Environmental Minor Project Refinement Form

Project Name: West of Devers Upgrade Project Request Prepared By: Sylvia Granados

Date Approval Required: January 4, 2021 Variance Request No.: 43

FIGURE 1
 Page 1 of 9

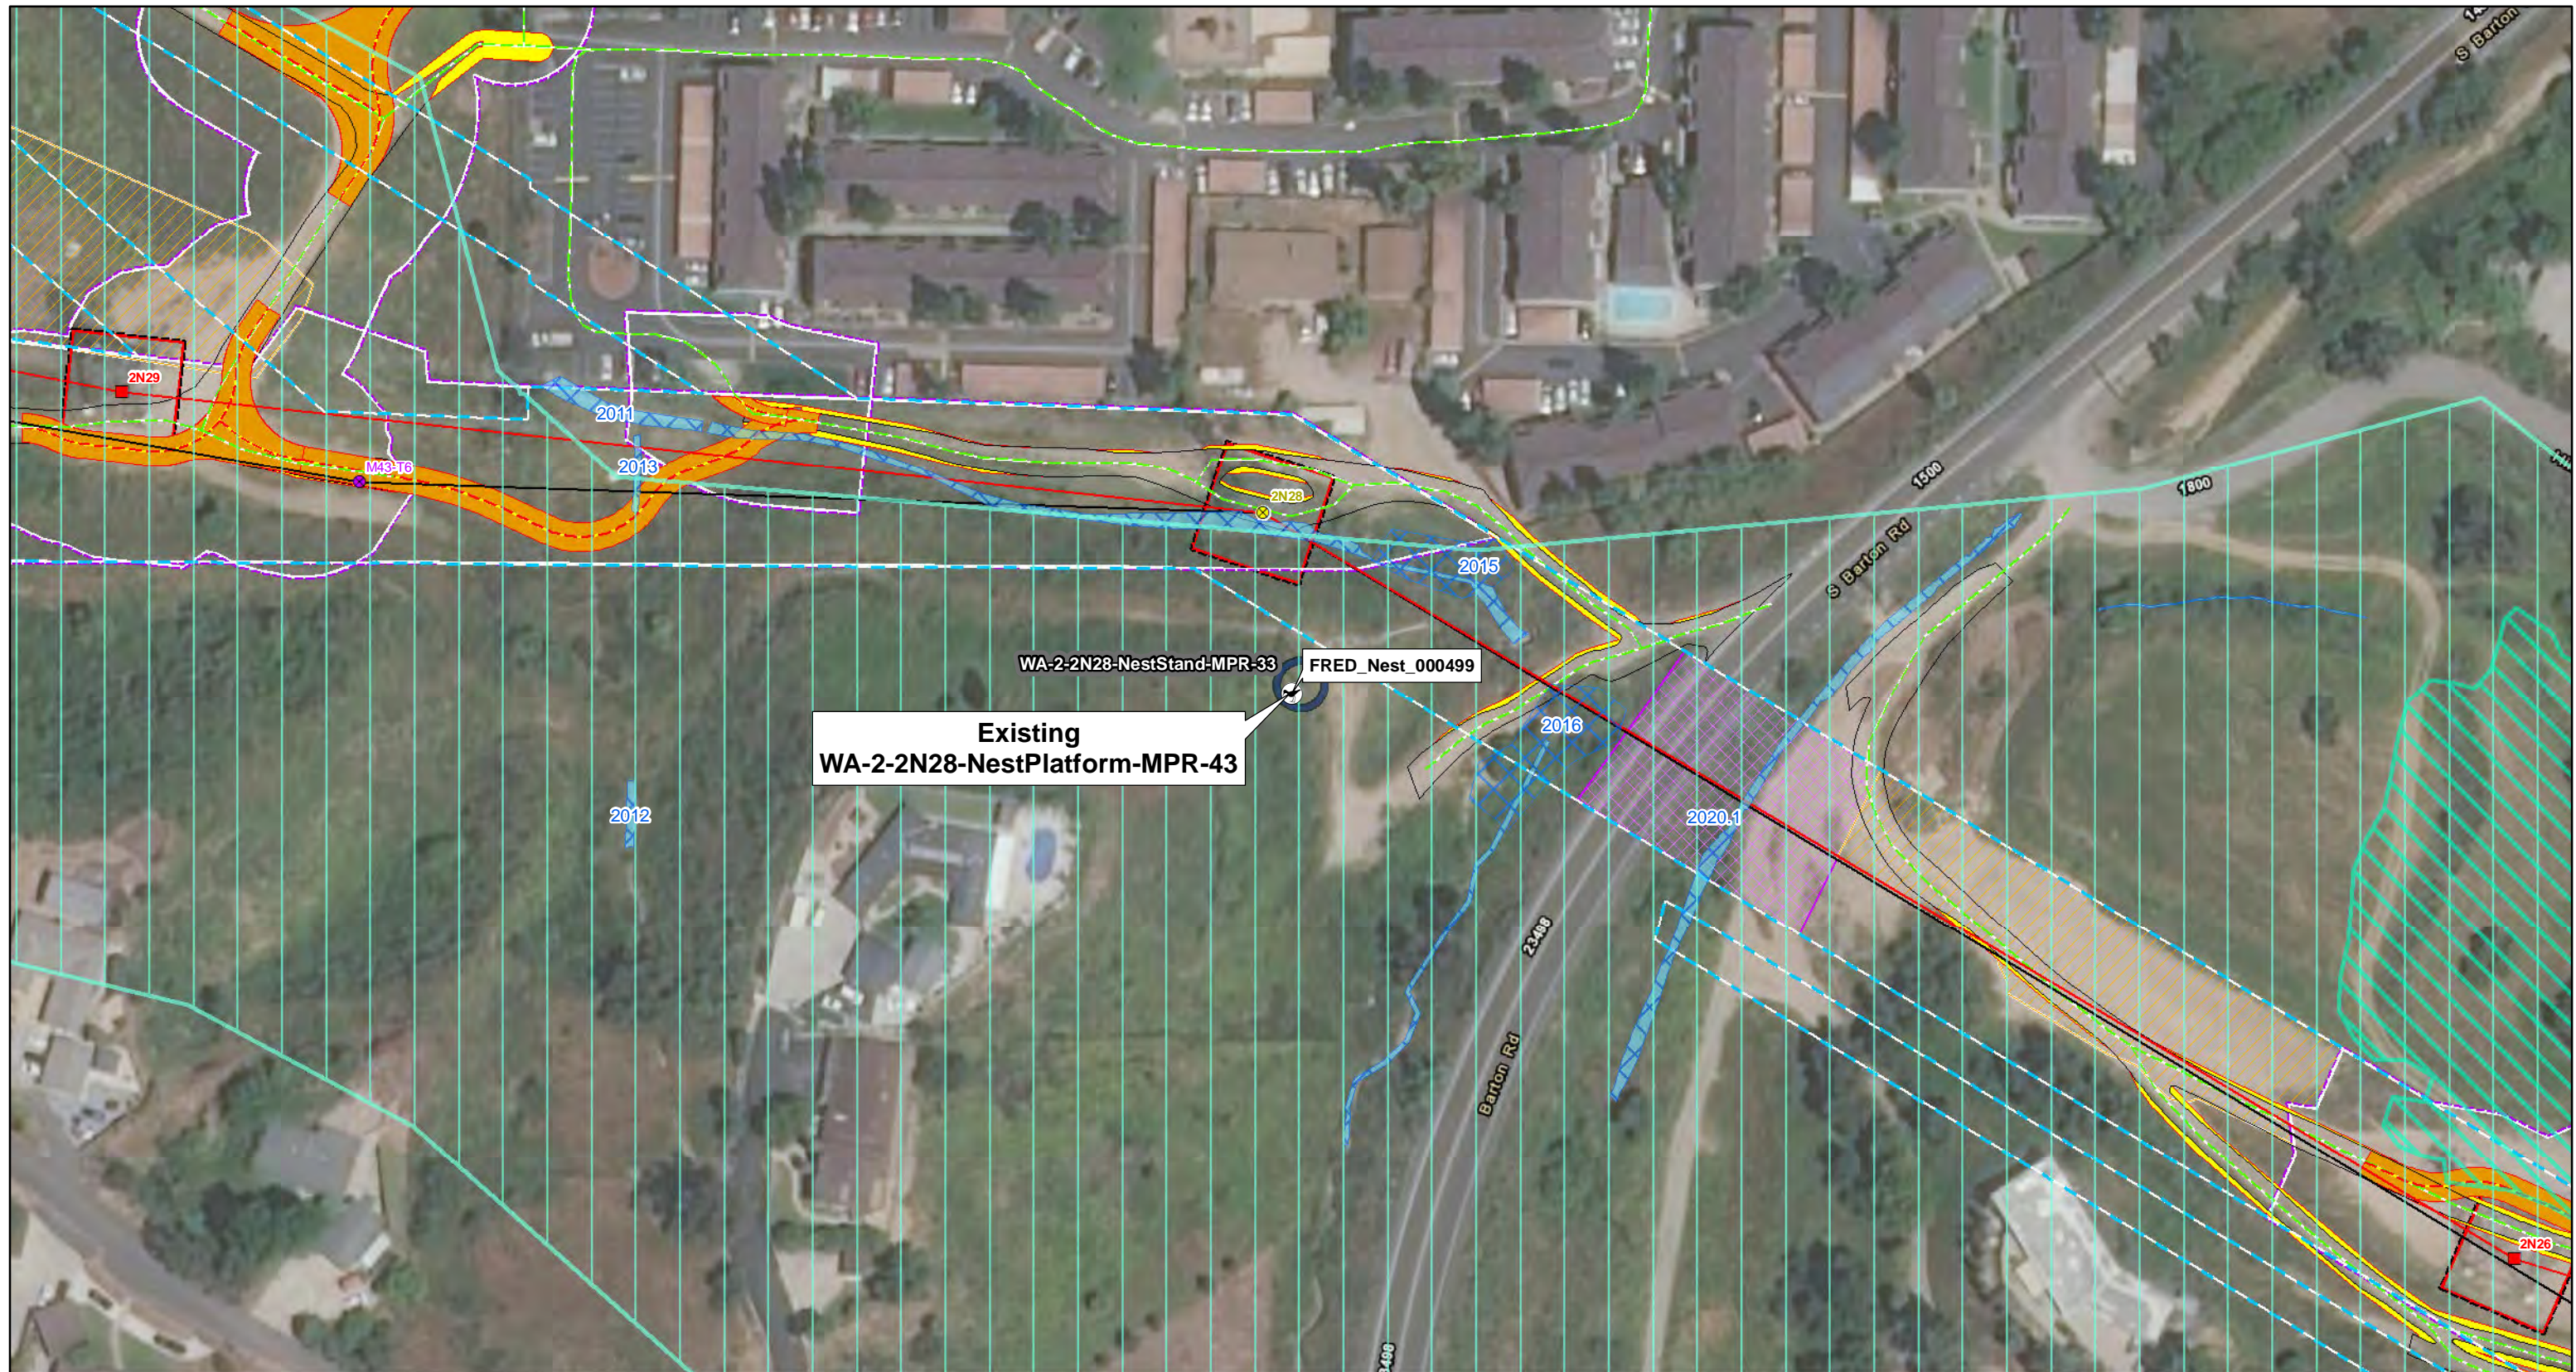
WA-2-2N28-NestPlatform-MPR-43 will permanently leave in place the artificial nest stand previously approved in MPR #33 (WA-2-2N28-NestStand-MPR-33) to provide a temporary alternate nesting substrate for Red-tailed Hawk (*Buteo jamaicensis*) [FRED Nest Event 000499](#), located approximately 100 feet southeast of 2N28, in an existing SCE tower structure. The existing tower structure, on which the nest platform is located, is associated with the existing SCE 115-kV Moreno-Moval-Vista circuit and associated O&M work area. The nest stand platform was approved on 1/9/20 as a suitable alternative nesting location, which will not be adversely affected by active construction or operational activities associated with the SCE right-of-way.

The nest stand location and access road, shown in Figure 1, Page 1, are located on property owned by the City of Grand Terrace within SCE's existing right-of-way. No additional work space or construction impacts will be required at the location.

FIGURE 1
Page 2 of 9

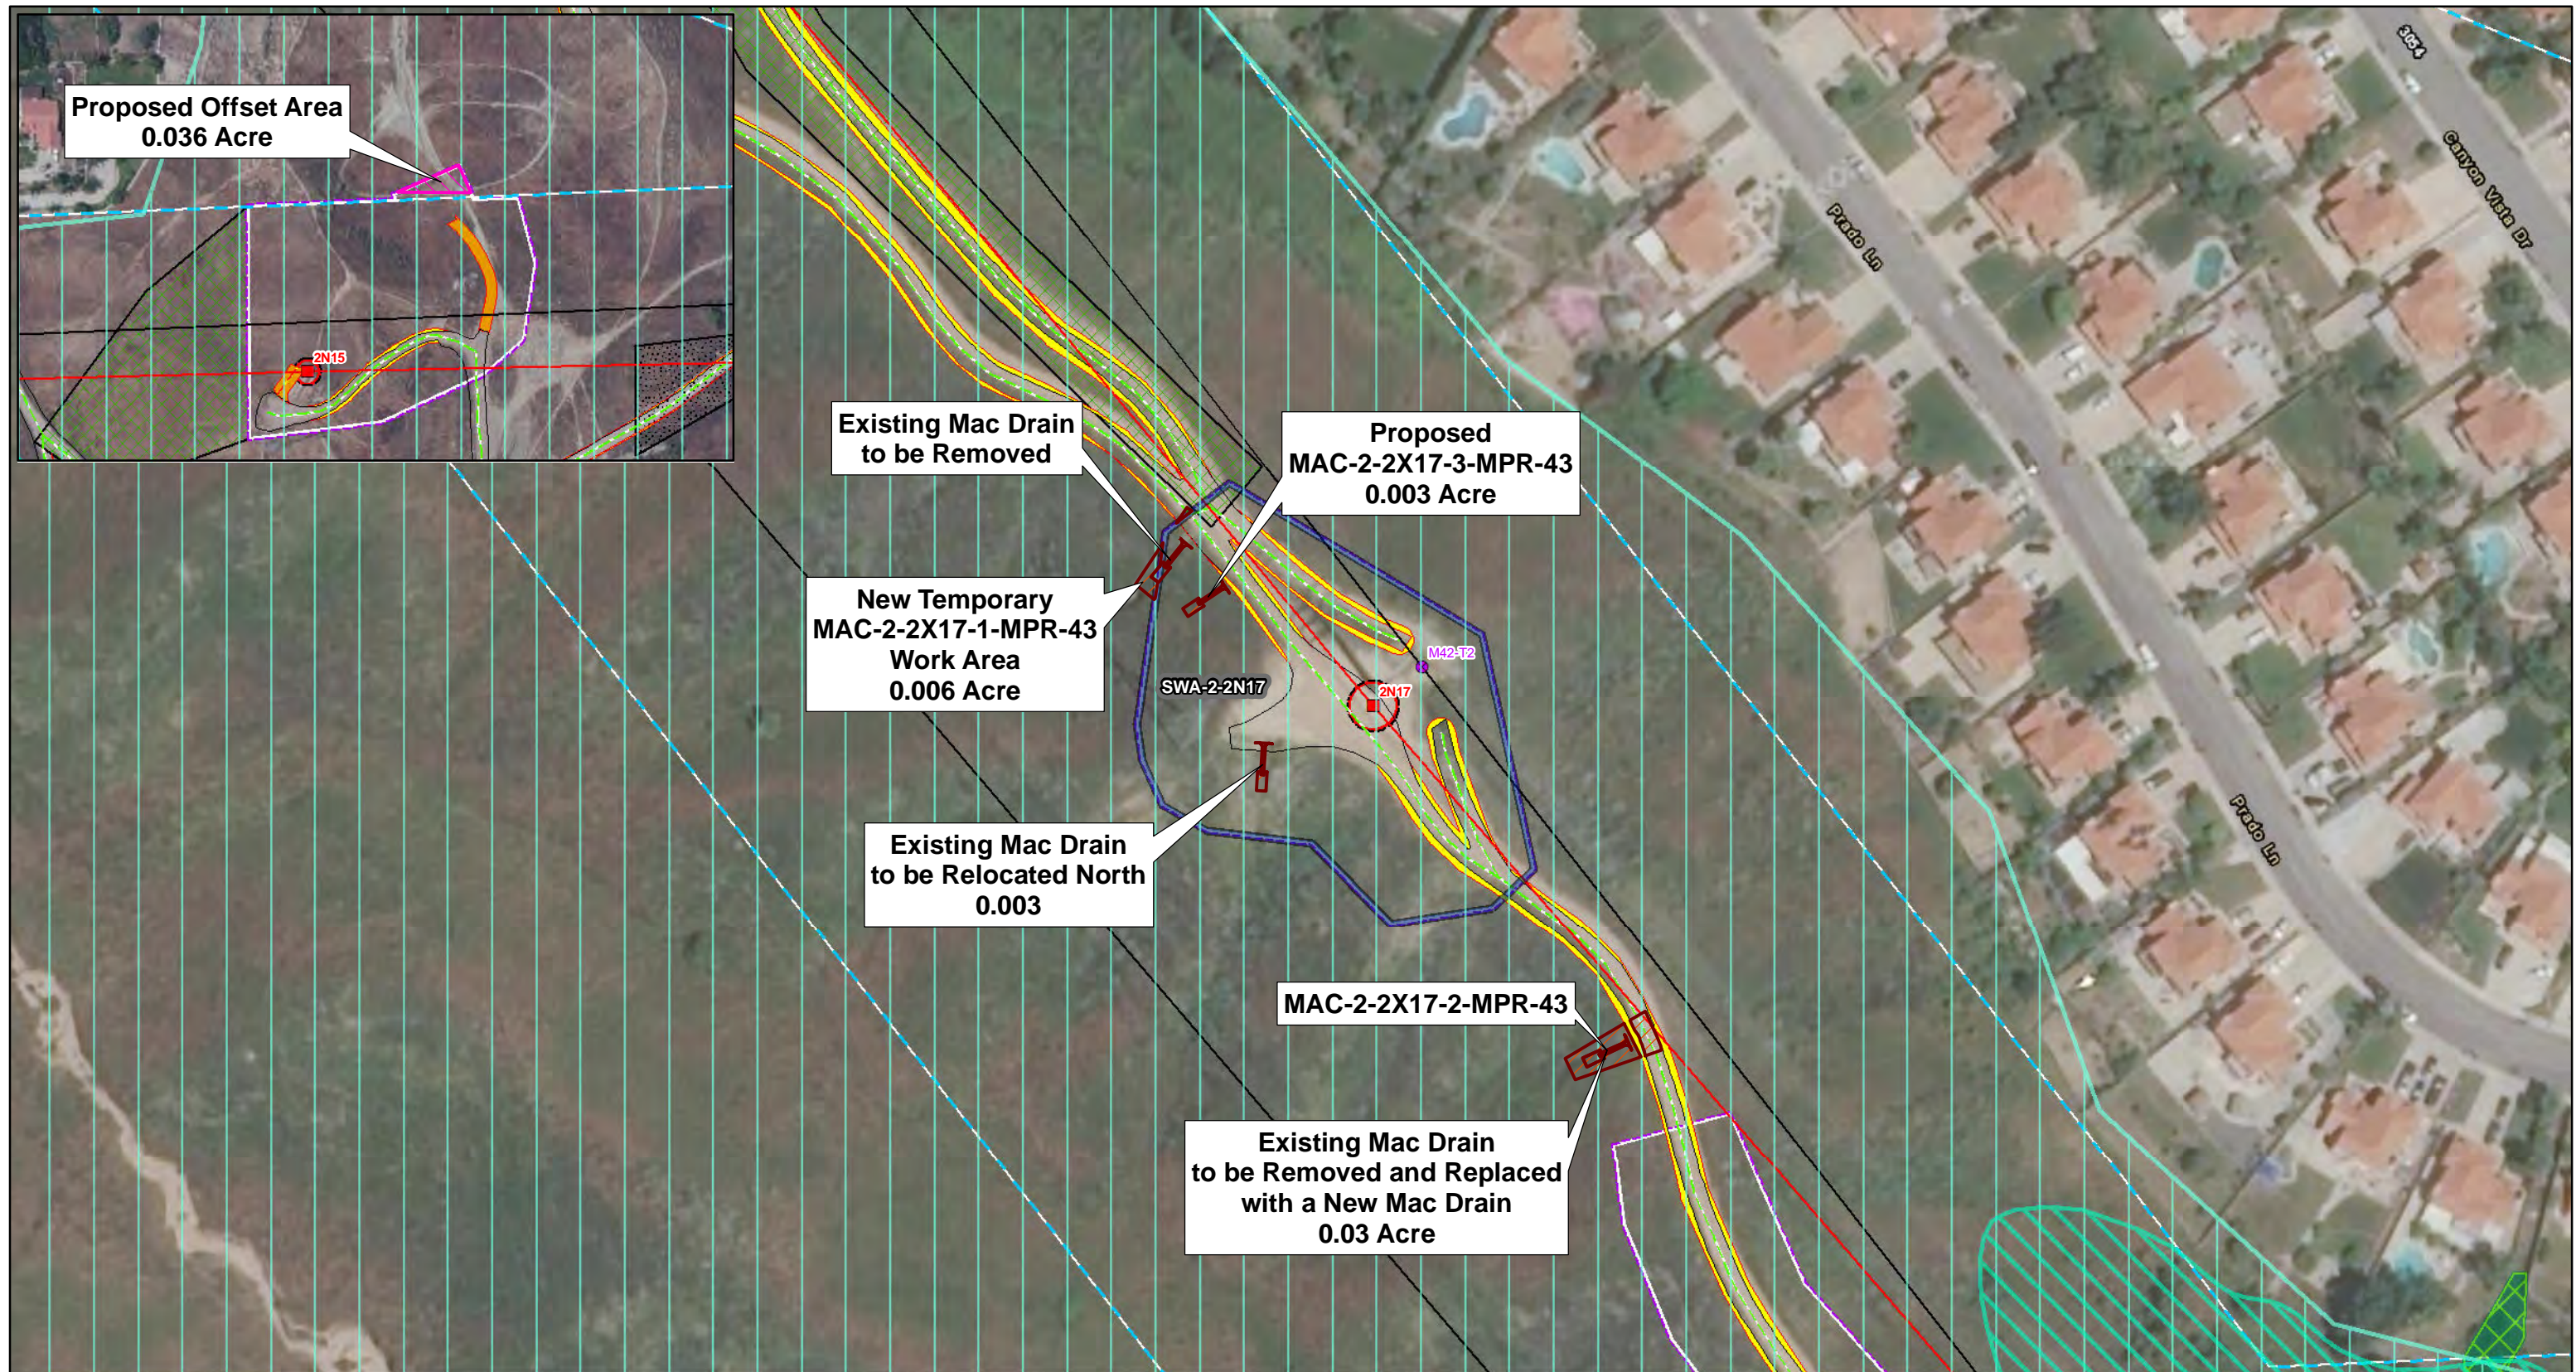
The proposed work within and around existing SWA-2-2N17 in Supersite 2X17 includes the removal of three existing non-Project related McCarthy Drains and replacement of two of the McCarthy Drains to better capture and divert surface flow from the access roads. The southernmost drain (MAC-2-2X17-2-MPR-43) shown in Figure 1, page 2 will be removed and replaced in the same location. The existing drain located within SWA-2-2N17 will be removed, restored, and relocated to the northeast (MAC-2-2X17-3-MPR-43) along the access road in SWA-2-2N17. The existing northernmost drain will be removed, restored, and require a 0.006 acre expansion of Supersite 2X17 complete the work at MAC-2-2X17-1-MPR-43.

The removal and replacement of McCarthy Drains will consist of a combined net increase in temporary impacts of approximately 0.036 acre consisting of 0.023 acre of coastal sage scrub and 0.013 acre of developed/disturbed land. The new work areas are located on private property within the WOD 500-kV SCE ROW utility corridor.

FIGURE 1
Page 3 of 9

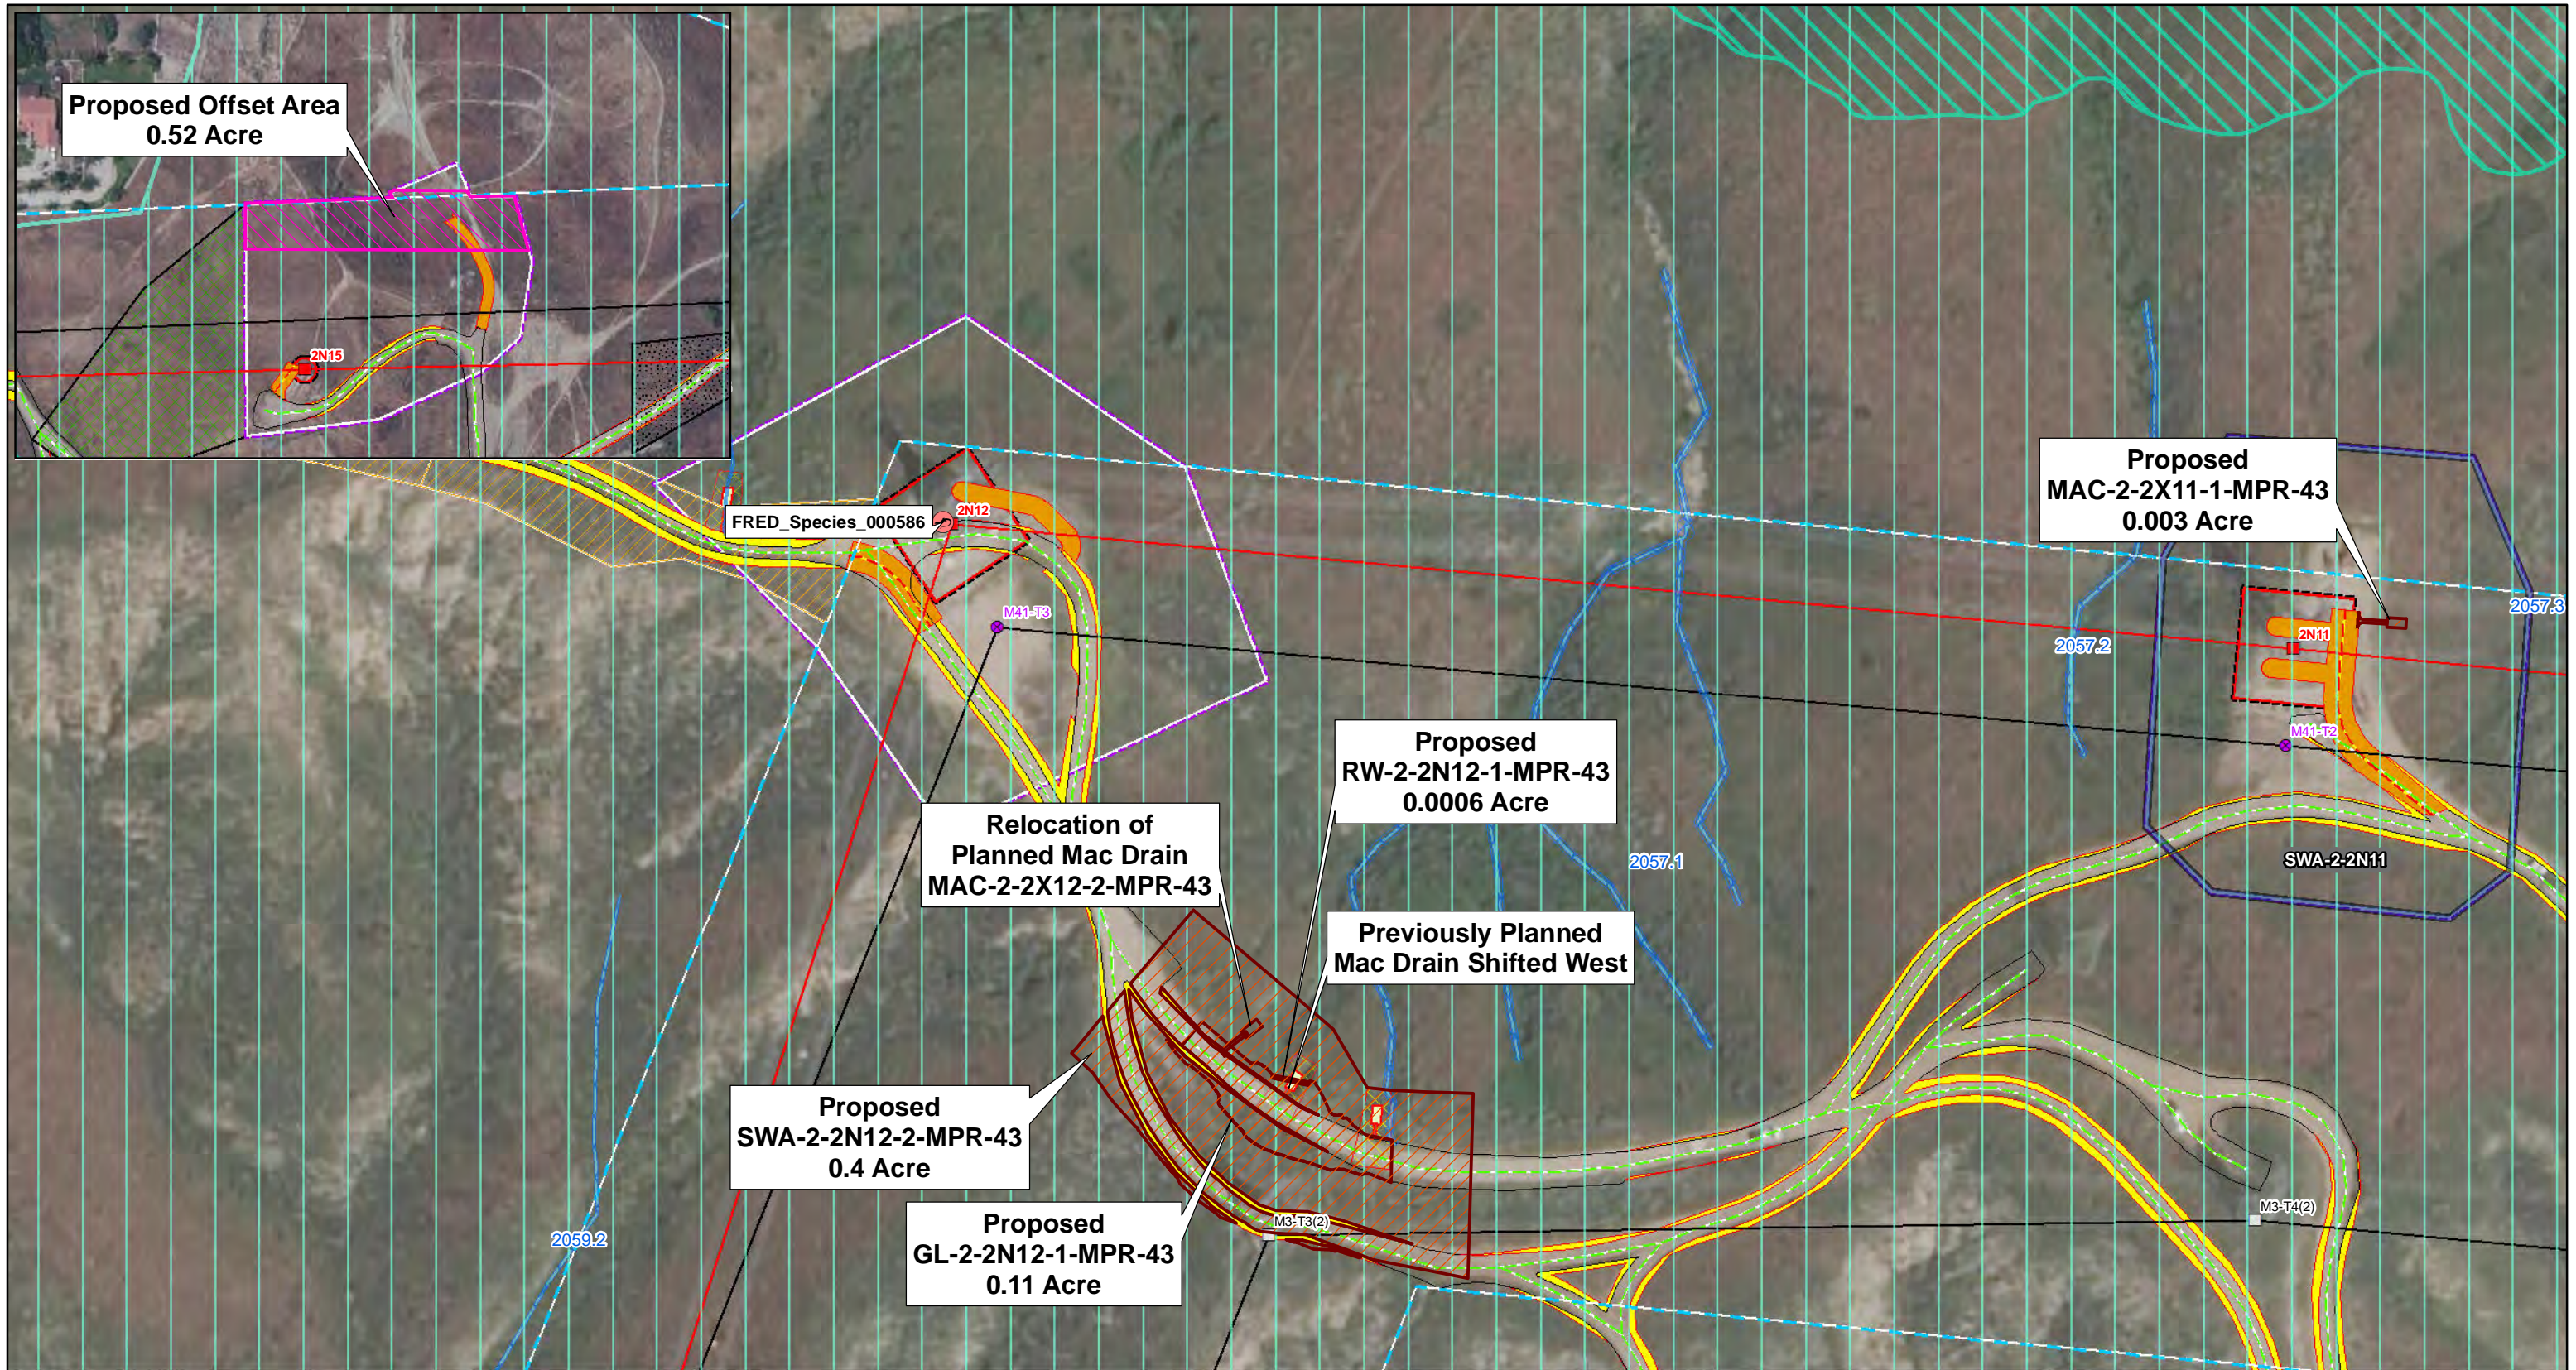
A new 0.40 acre temporary work area (SWA-2-2N12-2-MPR-43) is required to construct a 0.0006 acre retaining wall (RW-2-2N12-1-MPR-43), associated 0.11 acre access road expansion (GL-2-2N12-1-MPR-43), and mac drain relocation (MAC-2-2X12-2-MPR-43), as shown on Figure 1, page 3. MAC-2-2X12-2-MPR-43 was originally designed in the location where the retaining wall construction is required, and will therefore be relocated to the west to provide additional surface flow relief on the access road outside of the retaining wall construction. Approximately 0.11 acre surrounding the access road will be graded to complete the construction and better divert surface flows to the McCarthy Drains.

A new McCarthy Drain is proposed within Supersite 2X11 to provide surface flow relief from the tower pad. The proposed McCarthy Drain will be installed on the northeastern side of the tower pad. No new work area is required for the installation, as shown in Figure 1, Page 3.

The proposed work area within SWA-2-2N12-2-MPR-43 will result in a combined net increase in disturbance impacts of approximately 0.52 acre on private property located within the WOD 500-kV SCE ROW utility corridor, consisting of 0.082 acre coastal sage scrub, .116 acre grassland/forbland, and 0.322 acre of developed/disturbed land.
